METROPOLITAN GOVERNMENT OF NASHVILLE AND DAVIDSON COUNTY

STAFF RECOMMENDATION 1818 Wildwood Avenue November 20, 2013

Application: New construction-infill, Setback determination
District: Belmont-Hillsboro Neighborhood Conservation Zoning Overlay
Council District: 18
Map and Parcel Number: 11704013600
Applicant: Manuel Zeitlin, architect
Project Lead: Robin Zeigler, robin.zeigler@nashville.gov

<p>Description of Project: The applicant proposes to construct a back-to-back duplex on a vacant lot. The project would require a rear setback determination.</p> <p>Recommendation Summary: Staff recommends disapproval finding that the project does not meet the historic context of this portion of the Belmont-Hillsboro neighborhood, specifically sections II.B.1.a, b, c, e, f and i of the design guidelines. Additional information is required to asses sections II.B.1.d and h. If the Commission disagrees, staff recommends that the applicant be asked to defer the project so that the additional information needed may be reviewed.</p>	<p>Attachments A: Photographs B: Site Plan D: Elevations</p>
--	--

A0

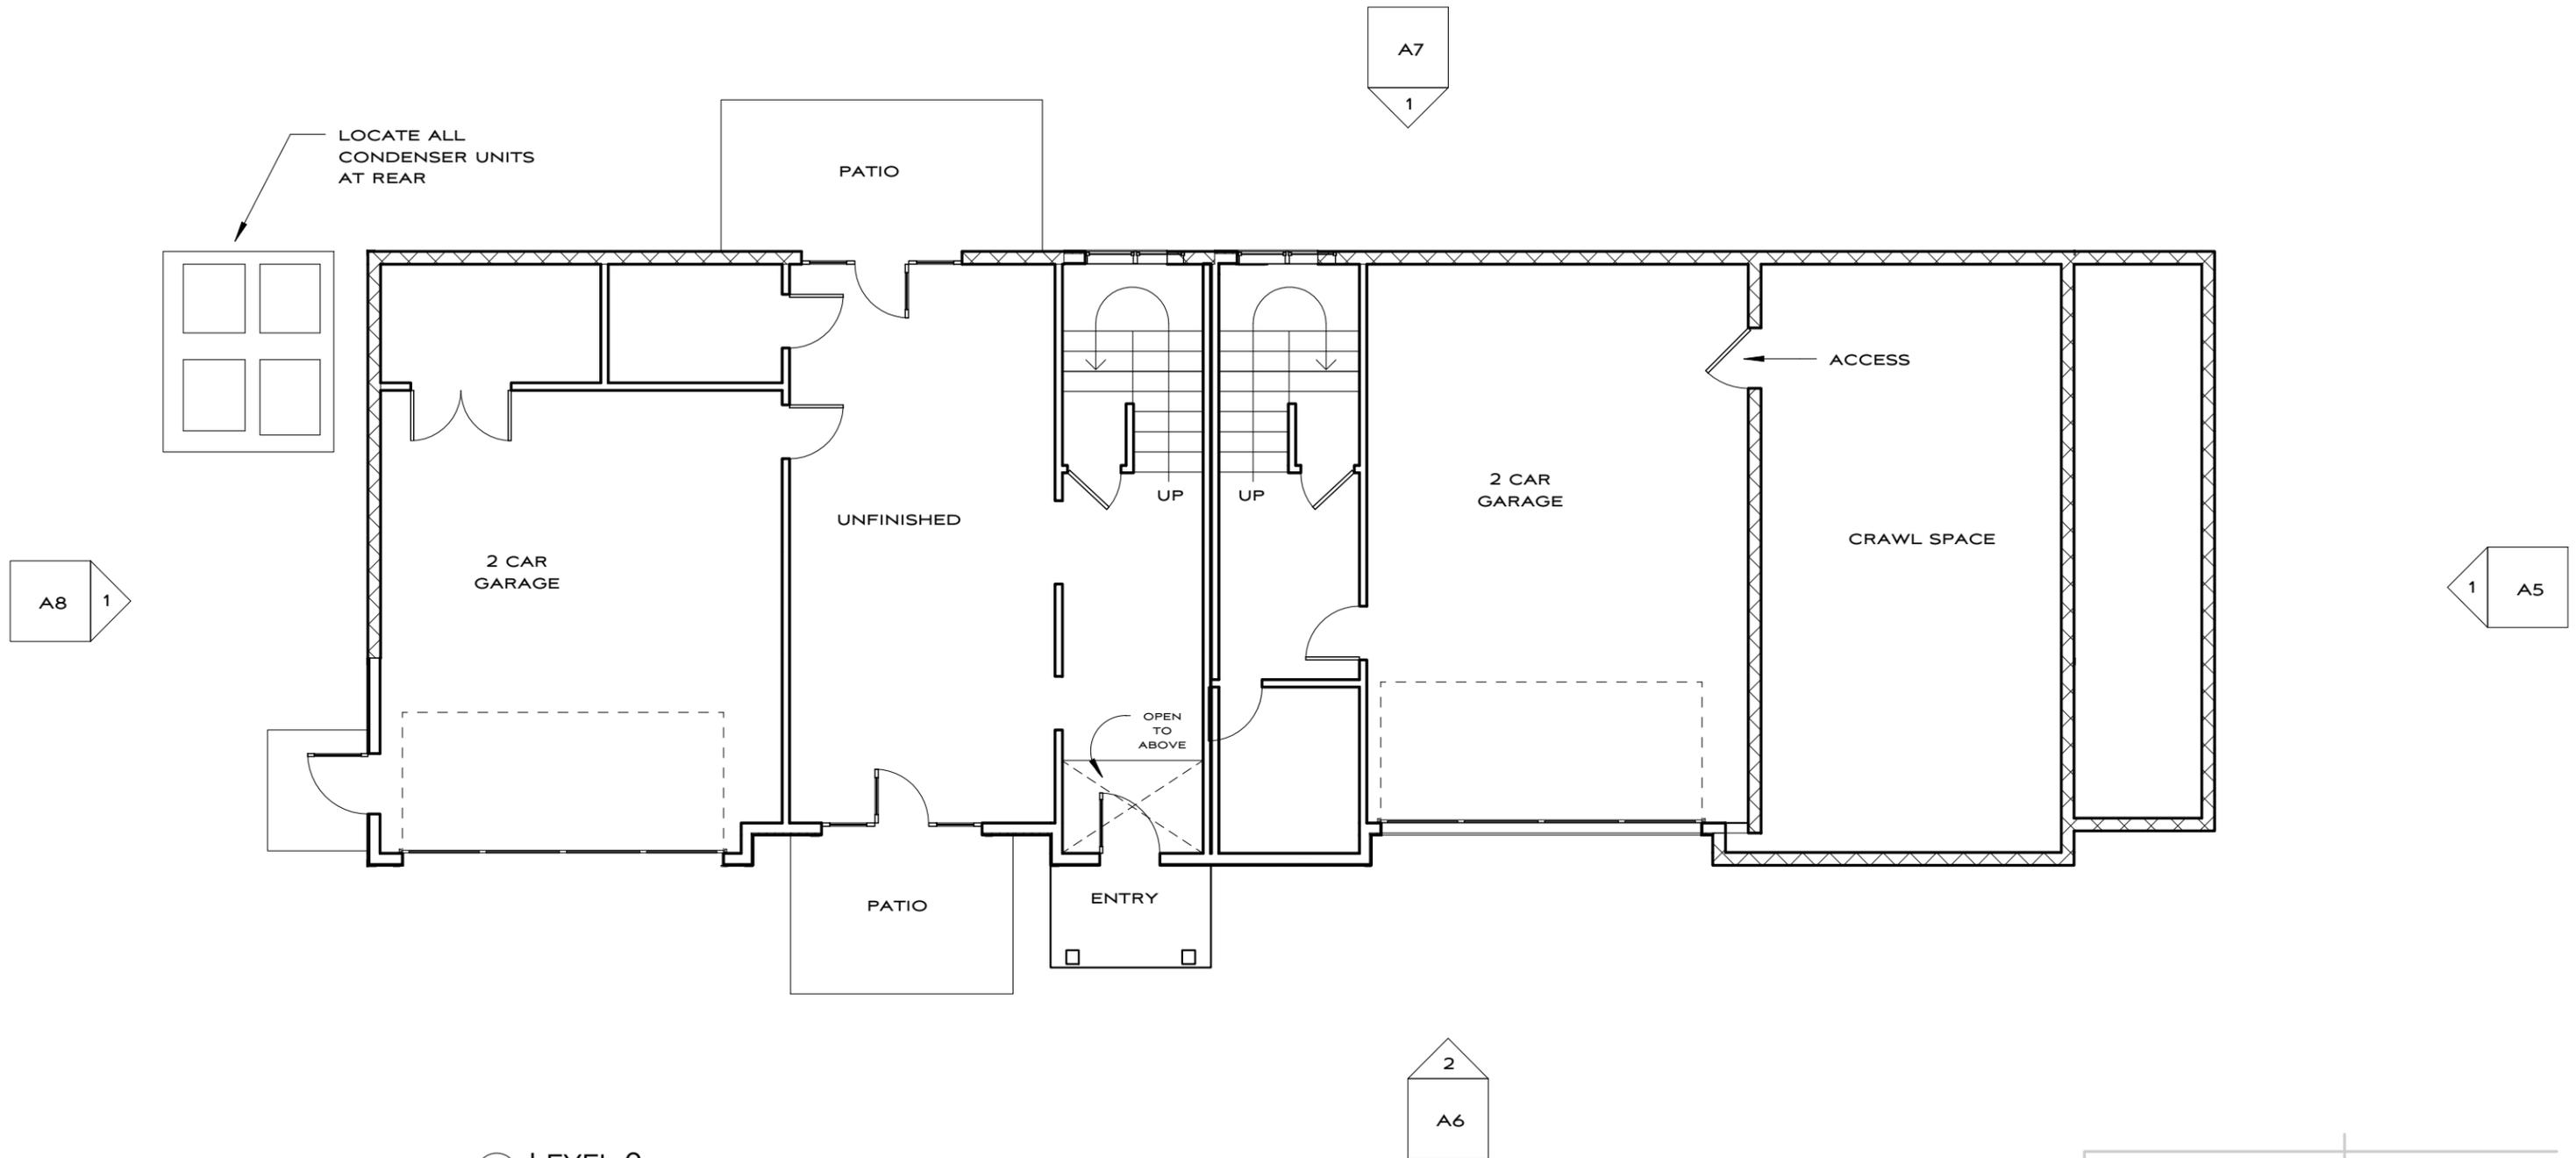
Setback & Rhythm of Spacing: The house is roughly centered on this slightly unusually shaped lot, similar to other homes in the area. The width is approximately thirty-two feet (32') wide. The width of the infill and the location together allows the structure to meet the rhythm of spacing established by the post-war homes on this block.

The front setback is similar to the historic home that was previously on this lot and the homes to either side. The project meets all bulk zoning requirements with the exception of the rear setback which is less than the required twenty-feet (20') (approximately 15'), as measured from the corner closest to the rear property line. Due to the size of the lot, the ability to capture upper level space because of the drop in grade, and the context which has far less lot coverage than what is proposed, (see maps on page 2), staff can find no reason to allow for a new rear setback determination. The project does not fully meet section II.B.1.c.

A2

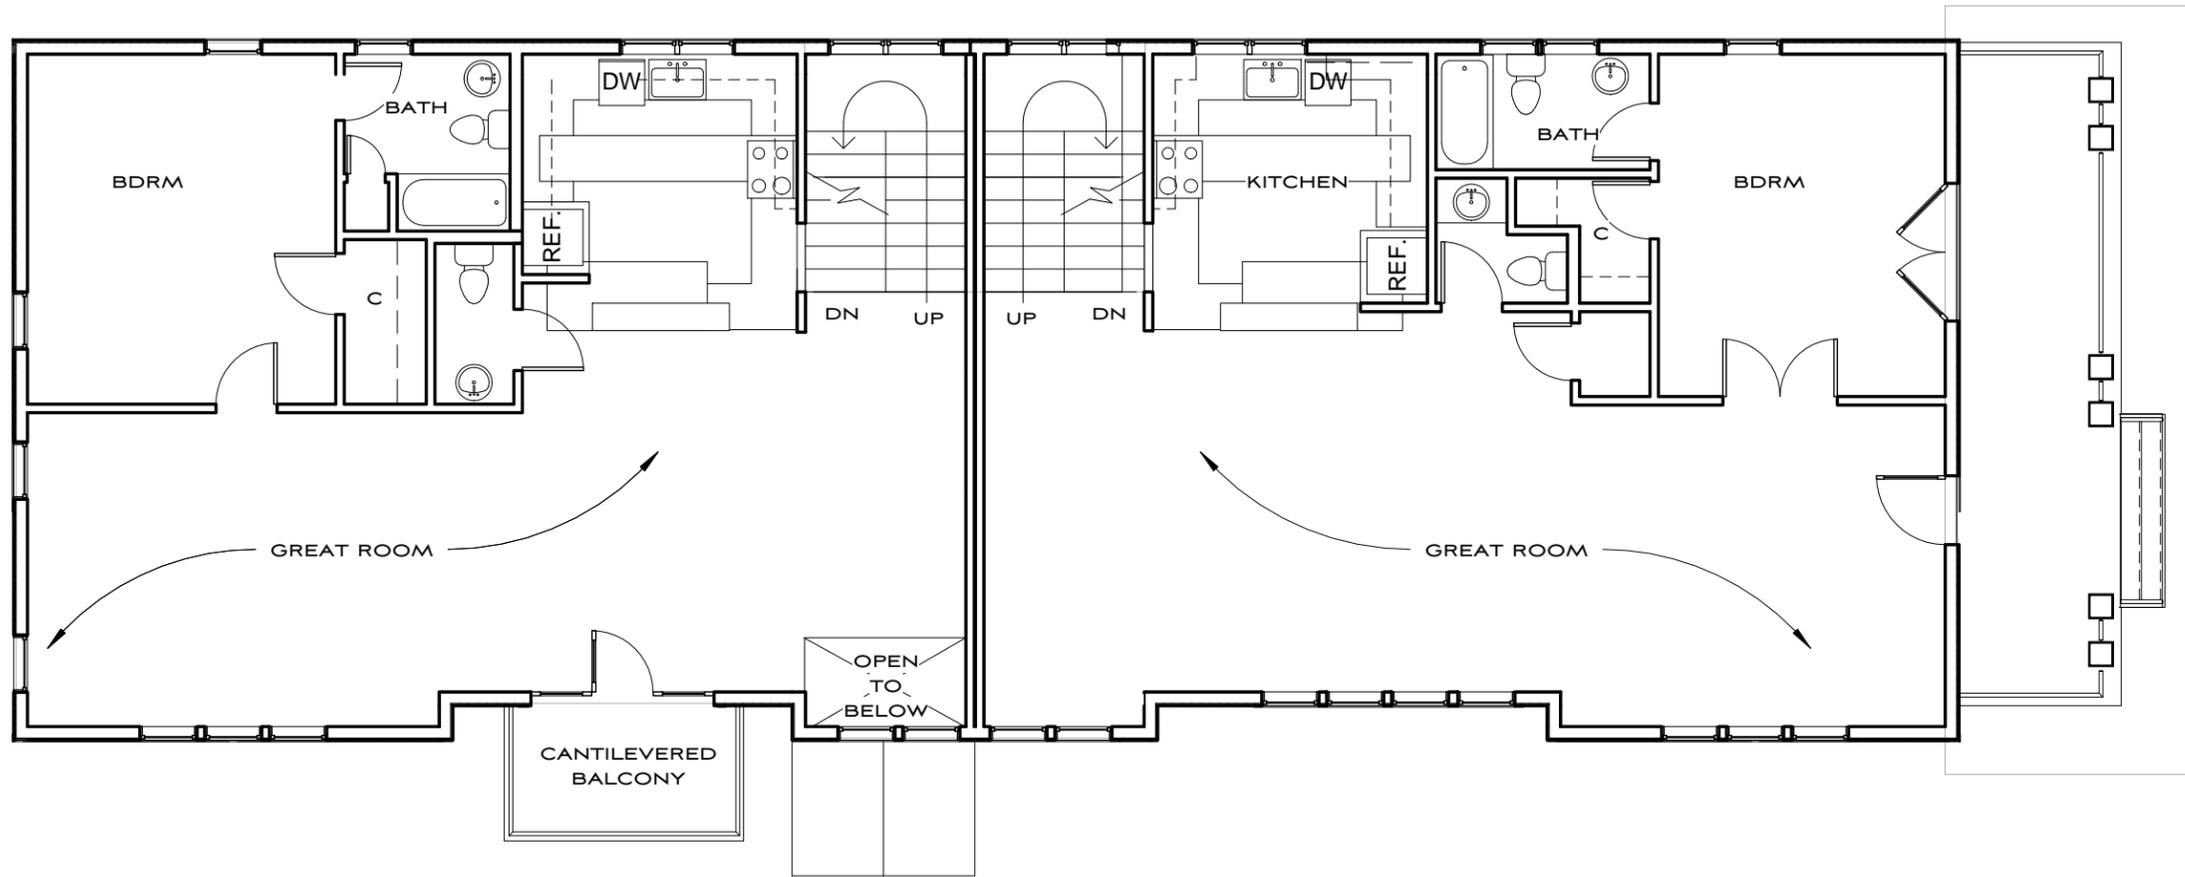
Orientation: The primary entrance is oriented towards the street in a similar way as the historic home it has replaced; however, it also includes a full-width porch oriented

towards the street, which is an unusual condition for the post-war homes that make up the context. These homes have no porches but may have simple hoods over the entrance. The second primary entrance, for the rear unit, is on the left side of the house, towards the middle of the lot, an inappropriate orientation for a historic building. Primary entrances should be oriented towards the street. The project does not meet section II.B.1.f.

A4

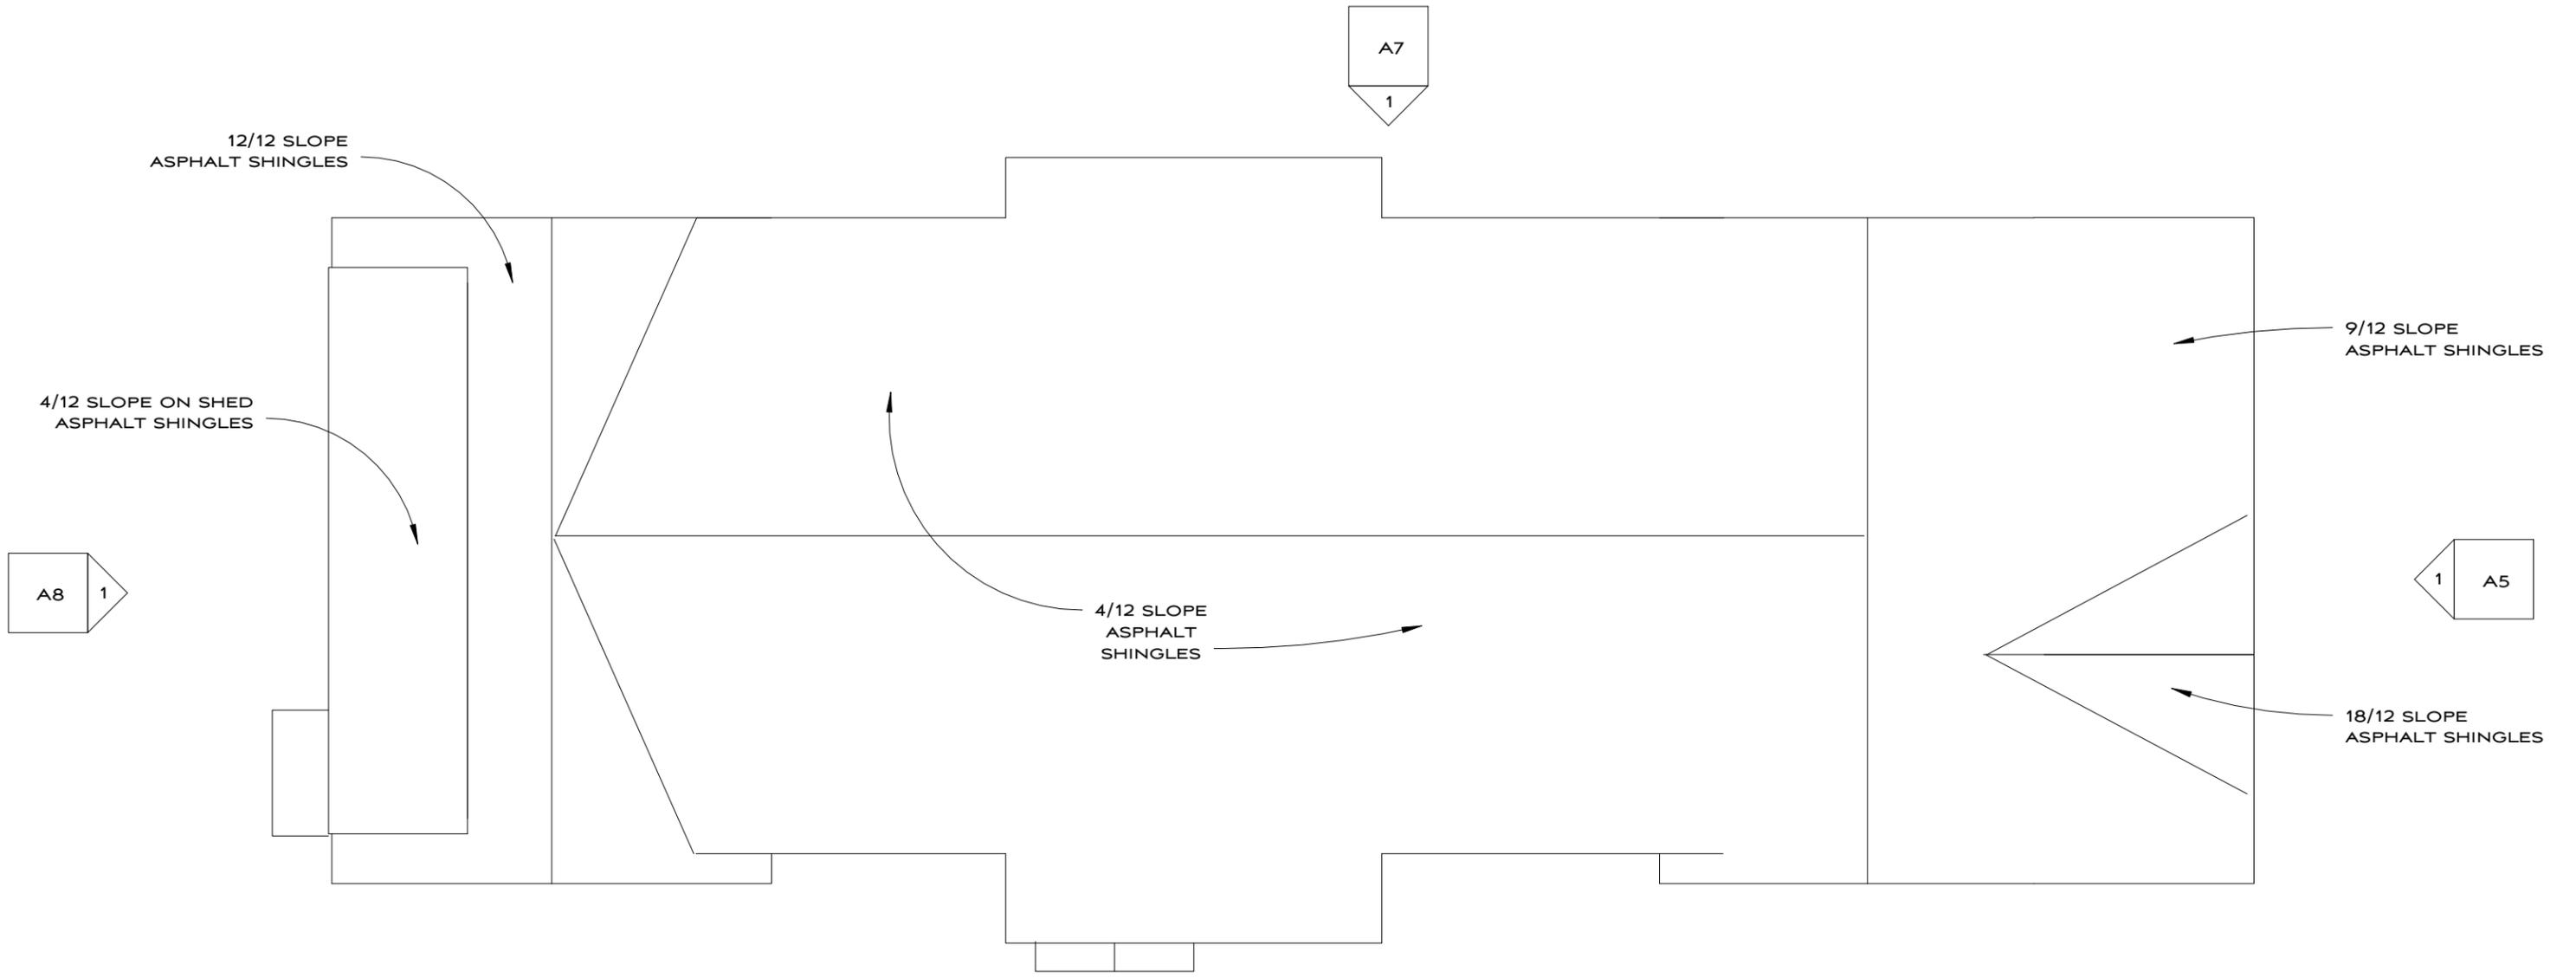
Roof form: The primary roof form, as seen from the street, is a side gable house with a 9/12 pitch. The bulk of the addition will have a ridge running from front to back with a 4/12 pitch. Taking into account the context explained under "background", the roof pitch is too steep. The majority of the post-war homes have a lower pitch, closer to a 6/12 pitch. Although the bulk of the building's roof form is more appropriate, the primary and most visible pitch is too steep. The project does not meet section II.B.1.e.
